## Lloyd's Register of Shipping.

Ship's Name S.S. "MACVILLE"

Memorandum of alterations reported since ship was surveyed for assignment of Load Lines  
in 1/19/5

PLAN OF FO'CLE.ALTERATIONS.

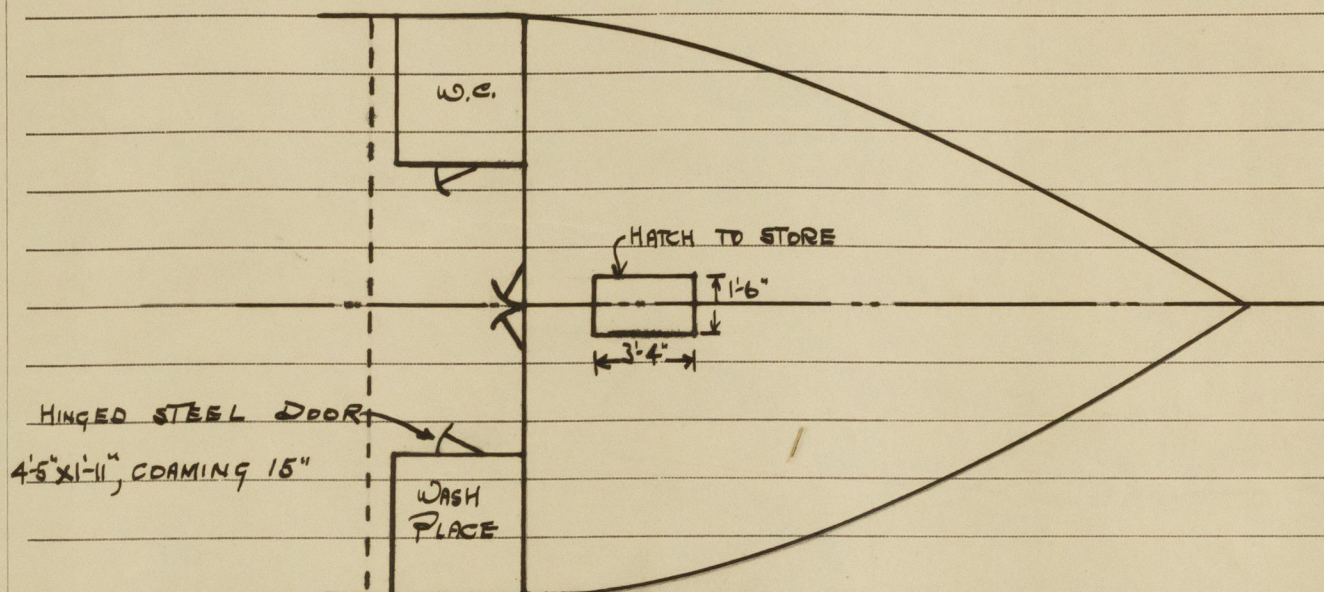
Hatch to chain locker plated over.

Hatch to store plated over and new hatch fitted as shown in above sketch.

Particulars of new hatch

Dimensions 3'-4" x 1'-6"

Coaming 10" x 3/8"

Wood cover 2 1/2"

Plats, battens &amp; tarpaulin supplied.

Hinged steel door to crew's workplace :- Door increased in size from 4'-0" x 1'-11" to 4'-5" x 1'-11" and coaming altered from 18" to 15".
